U.S. CONSUMER PRODUCT SAFETY COMMISSION
4330 EAST WEST HIGHWAY
BETHESDA, MD 20814

December 1, 2015

On November 2, 2015, U.S. Consumer Product Safety Commission ("CPSC") staff received the Canvass Draft of the proposed American National Standard for Recreational Off-Highway Vehicles, ANSI/ROHVA 1-201X.¹ Staff appreciates the opportunity to comment on the canvass draft and is very pleased to see ROHVA taking significant steps to improve the voluntary standard with the addition of requirements in the areas of lateral stability, vehicle handling, and occupant protection. CPSC staff supports the proposed changes to the voluntary standard and believes the aggregate effect of improved vehicle stability, handling, and occupant protection will reduce injuries and deaths associated with ROV rollovers.

<p>Figure 31: Vehicle H Side View</p>	 <p>Figure 32: Occupant H at 45° Roll</p>
<p>Figure 1. Vehicle H with shoulder and lap belt, without shoulder barrier.</p>	<p>Figure 2. Occupant coming out of the safety zone during a simulated roll over. Seatbelt does not have a tilt sensing ELR.</p>

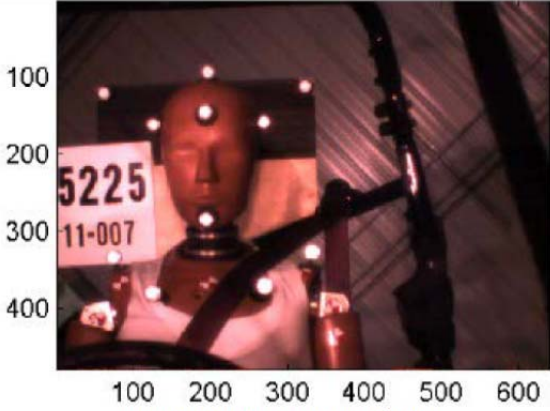
CPSC Staff's Comments. On July 7, 2015, CPSC staff sent a letter to OPEI, and provided a copy to ROHVA, explaining staff's concerns that the seat belt requirements in a pre-canvass draft version of the voluntary standard appeared to allow manufacturers to omit ELR technology in seat belts. Staff provided results from roll simulation tests showing that a seat belt without ELR technology did not lock during a 90 degree roll, and consequently failed to restrain an occupant during a simulated rollover event.

SEA roll simulator testing showed that ROVs without a solid shoulder retention barrier and a tilt sensing ELR could result in the occupant coming out of the safety zone during a 45-degree roll over. Vehicle H shown in Figure 1 does not have a passive shoulder barrier, nor was it equipped with a tilt sensing ELR. CPSC staff's testing of Vehicle H shows that the seat belt does not lock

throughout a 90-degree tilt range. Figure 2 shows the seat-belted occupant coming out of the protective zone of the rollover protective structure (“ROPS”) during a simulated roll over.

CPSC staff believes that the combination of the belt routing and the tilt sensing ELR contributed to limit occupant excursion.

CPSC Staff Recommendation #4: Staff recommends that ROHVA include a seat belt requirement for ELR with a locking angle determined by the manufacturer based on the vehicle's use, as recommended in the CPSC staff letter to ROHVA and OPEI on October 15, 2015.
